Groundwater Management Plan

Santa Clara River Valley Groundwater Basin, East Subbasin

December, 2003

Groundwater Management Plan Public Comments

Figure 3-2
Historical Groundwater Elevations
Santa Clara River Valley East Groundwater Subbasin

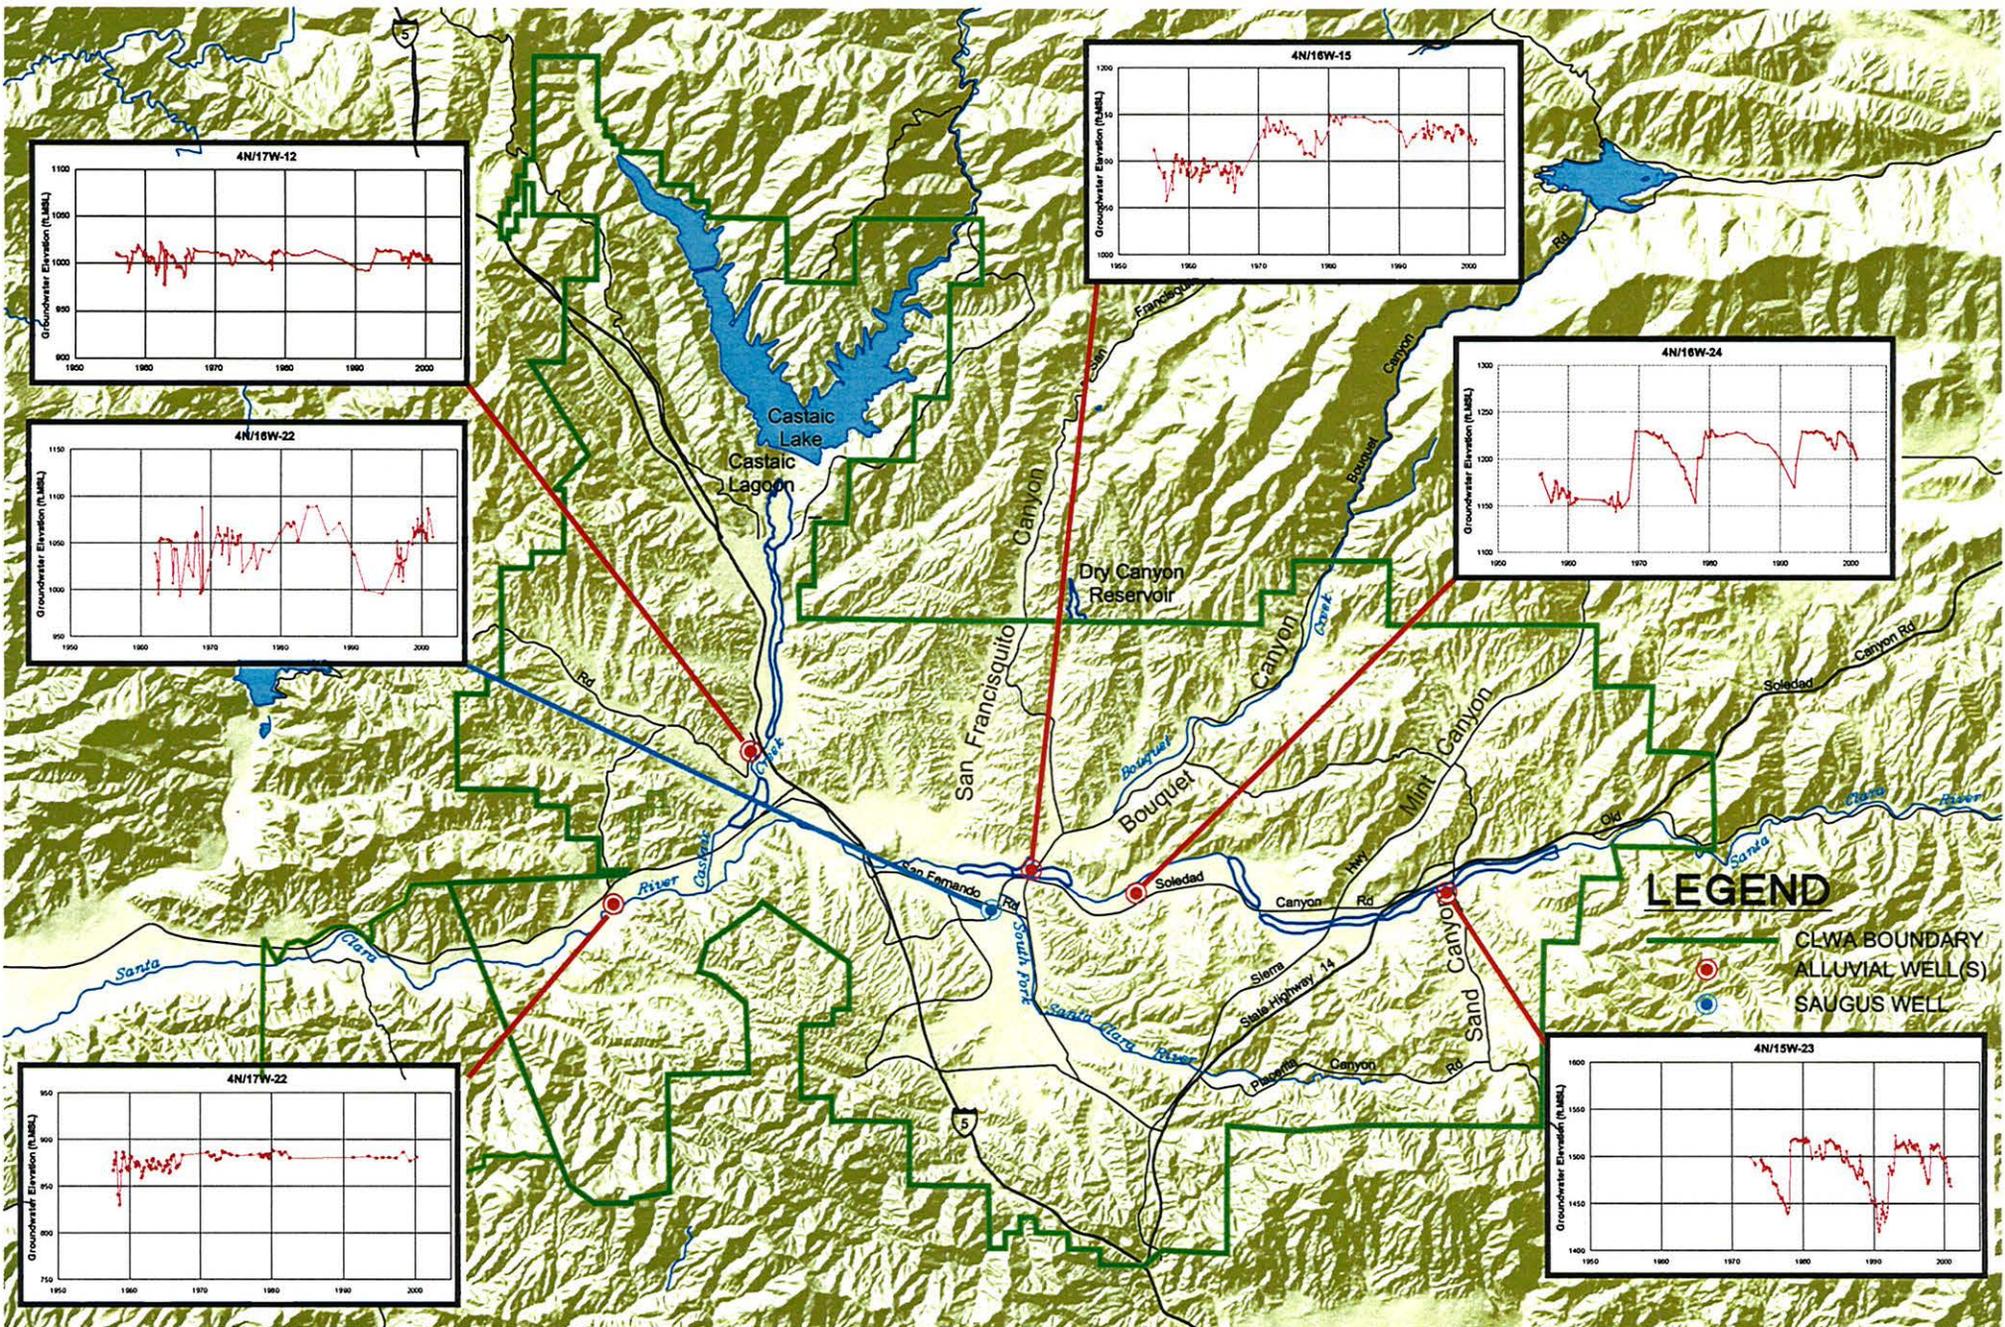
Figure 3-2. The vertical and horizontal scales associated with the hydrographs are very difficult to read. The T4N/R17W, Section 22 well, in the western arm of the Alluvial Aquifer does not show data from approximately 1983 through 1991. In previous reports and analyses, the NLF #C5 well was used for this area. This well depicted variable groundwater levels for the period from the mid-1980s to the early 1990s. Because this is the discharge area of the Alluvial Aquifer to the Santa Clara River, we need to understand the response of the system to the onset of agricultural pumping in this area in the mid-1980s. The T4N/R17W, Section 22 well does not possess the data needed to show that response;

Figure 5-1
Water Level Monitoring Well Network
Santa Clara River Valley East Groundwater Subbasin

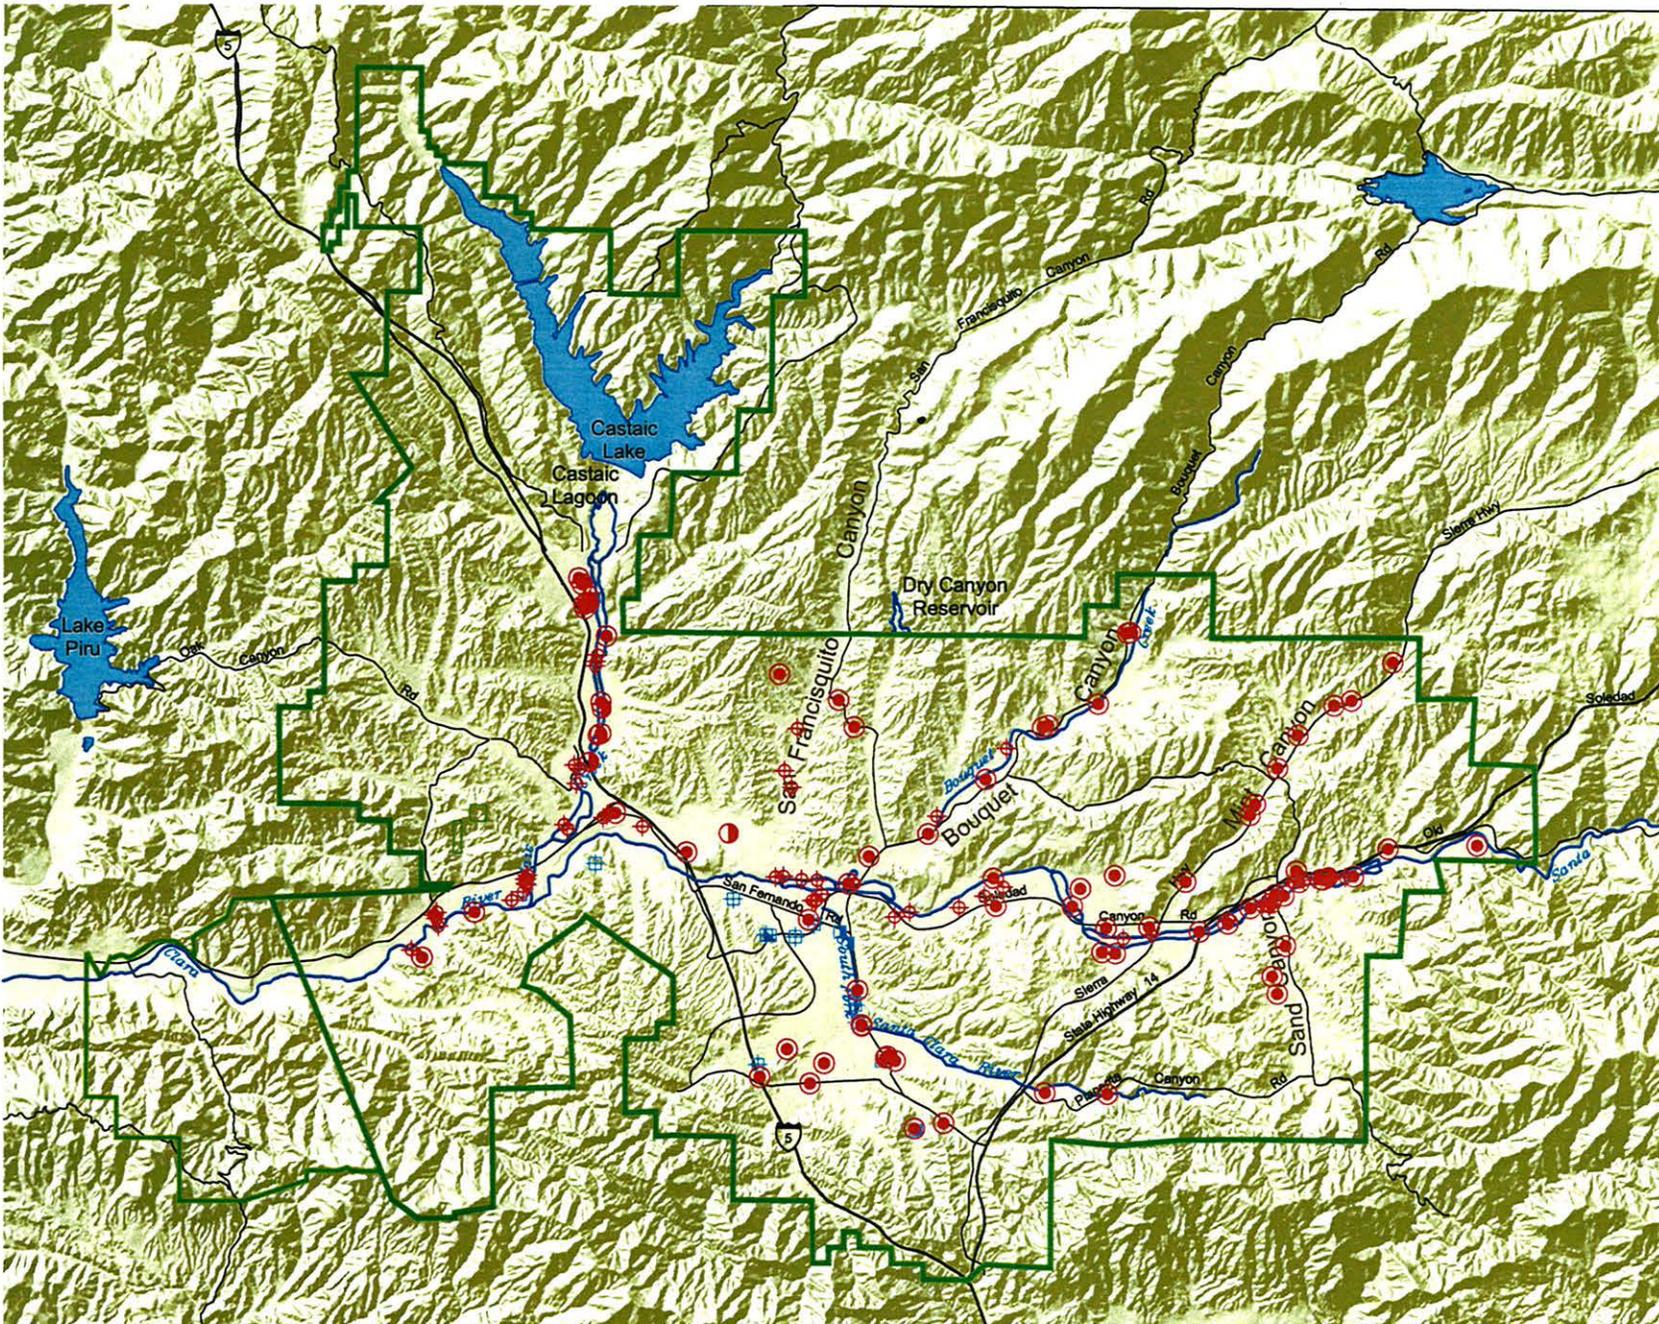
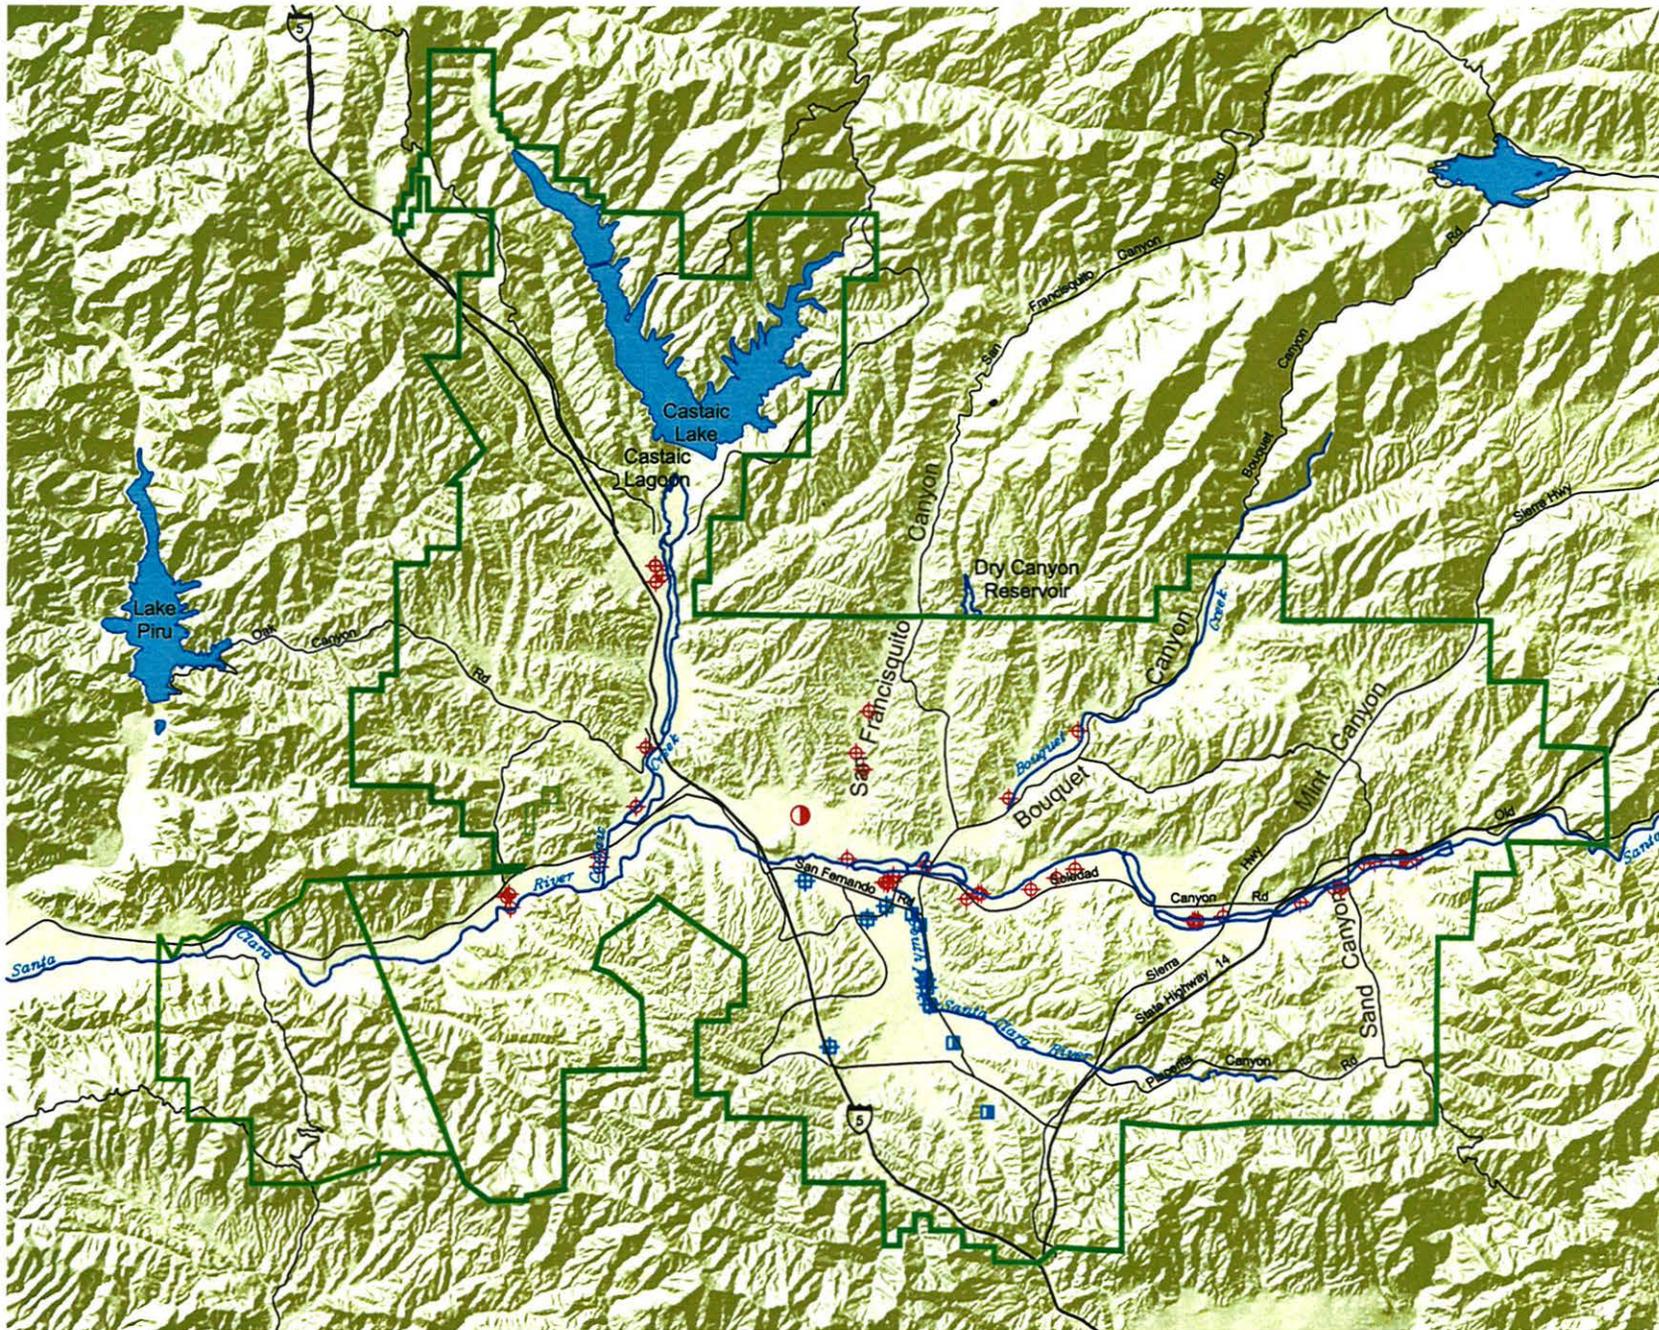
First, I commented previously on the proposed network of monitoring wells and the public availability of data. The monitoring wells in figures 5-1 and 5-2 appear to cover a wide range of the valley. However, the text on p. 27 states the network will be "mostly as illustrated in figures 5-1 and 5-2, but possibly expanded...." I hope the final network is extensive and covers all areas of the valley. Further expansion of the network would add valuable data points and should be encouraged.

Figure 5-3

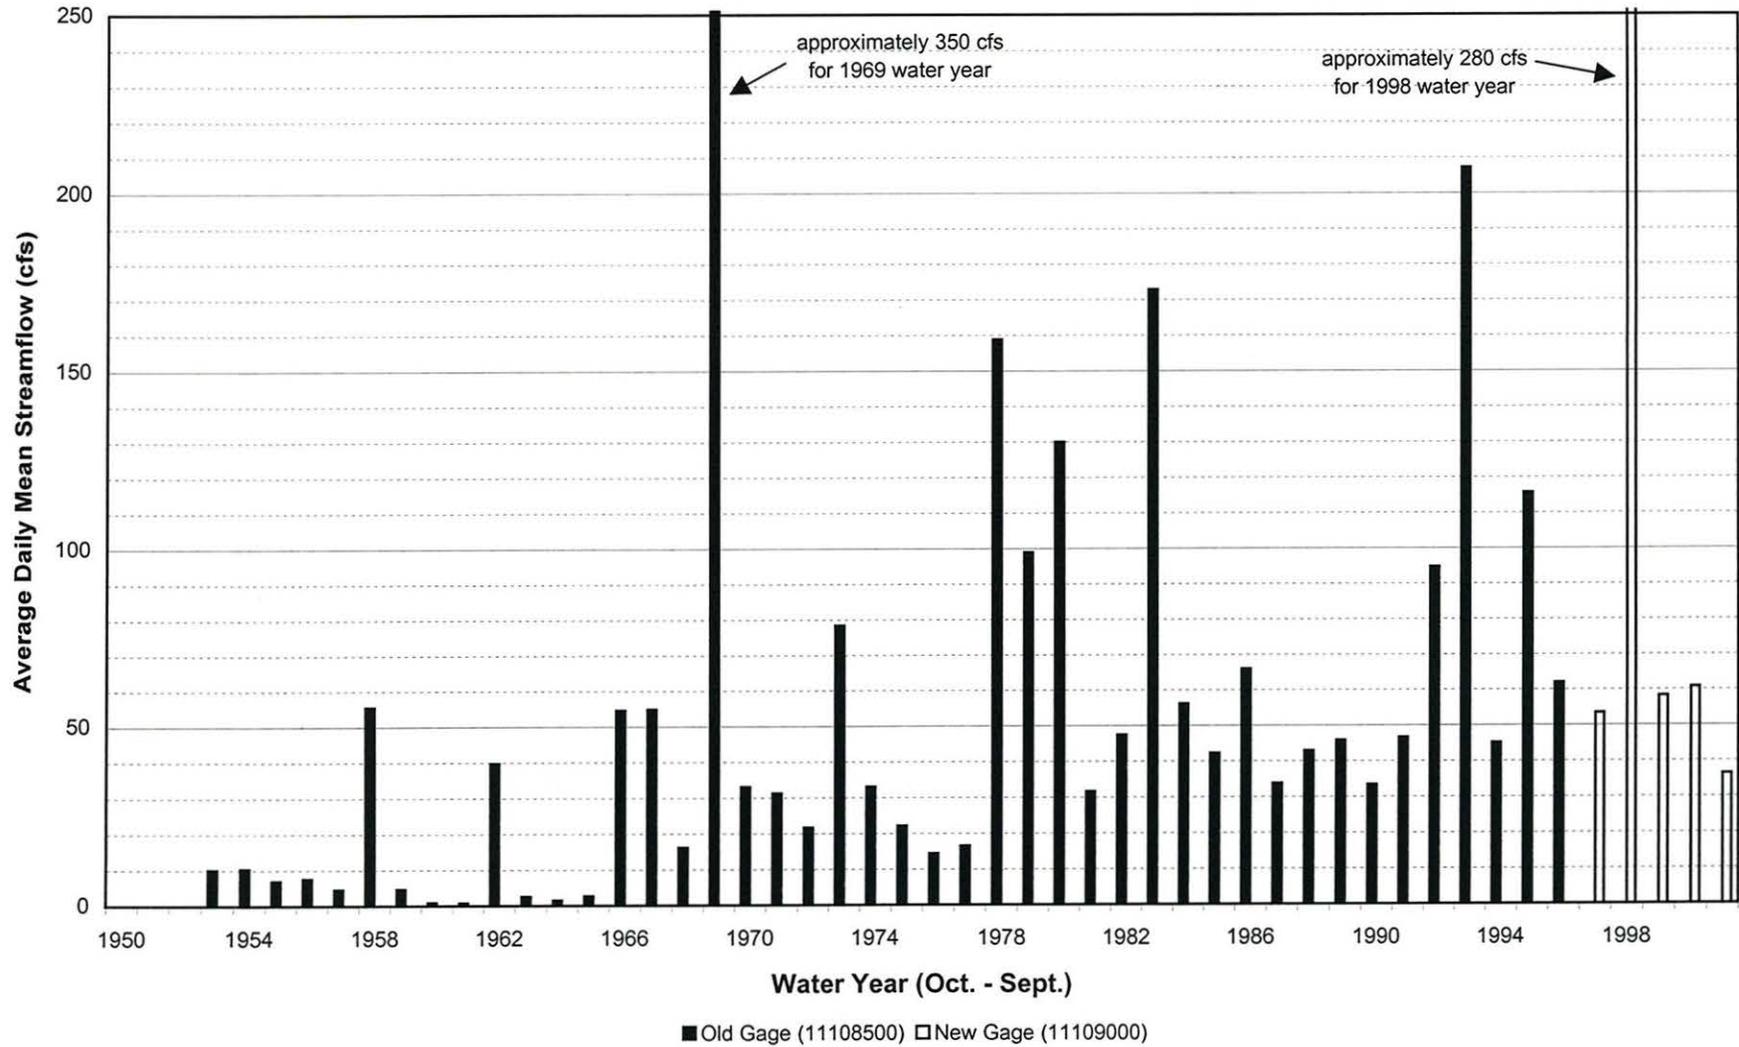
Figure 5-3. The average daily mean streamflow data appears to be shifted one year on the histogram graph. As an example to show the error, the histograms suggest that there were high flow years in 1968 and 1997. The high flow years were actually 1969 and 1998;

Figure 5-4

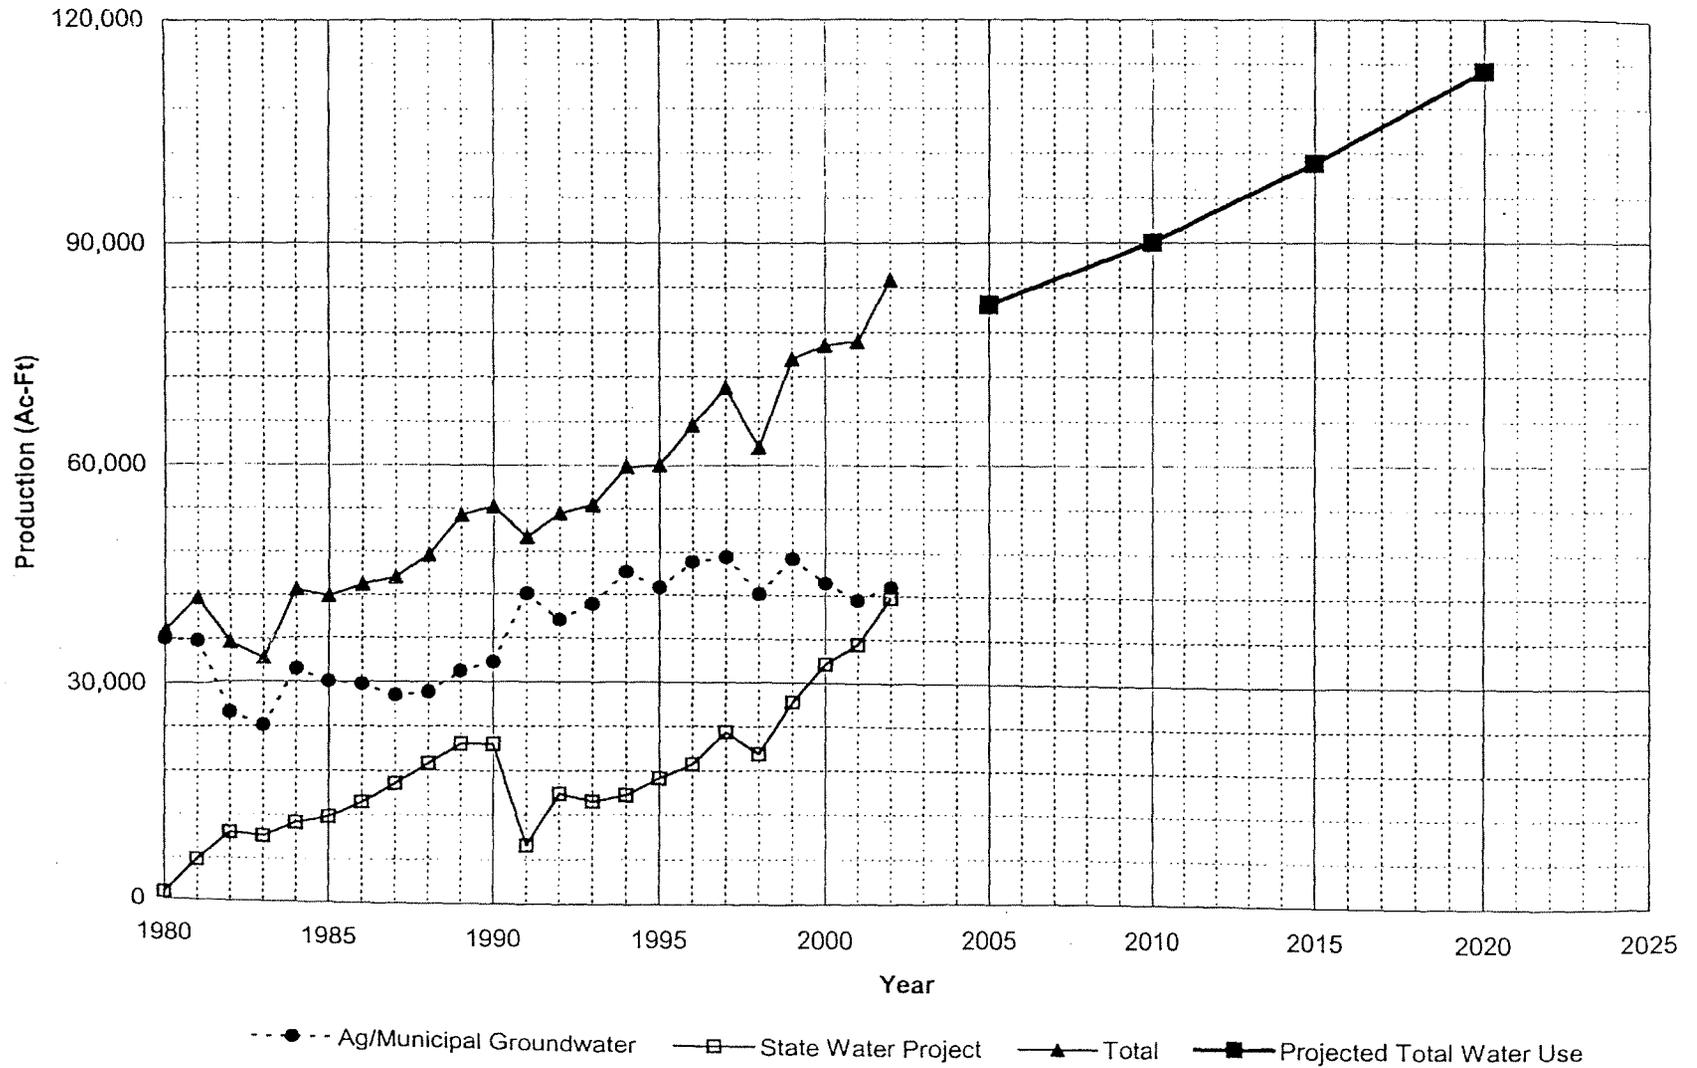
The SWP water received in 1991 is erroneous. The chart indicates 8,000 a/f. It is incorrect. CLWA only received 10% of its then allocation 54,200 a/f. The 10% was received in January and the plant shut down in March. See Exhibit A. It should be noted that this is a state water project interruption for months, not a reduction.
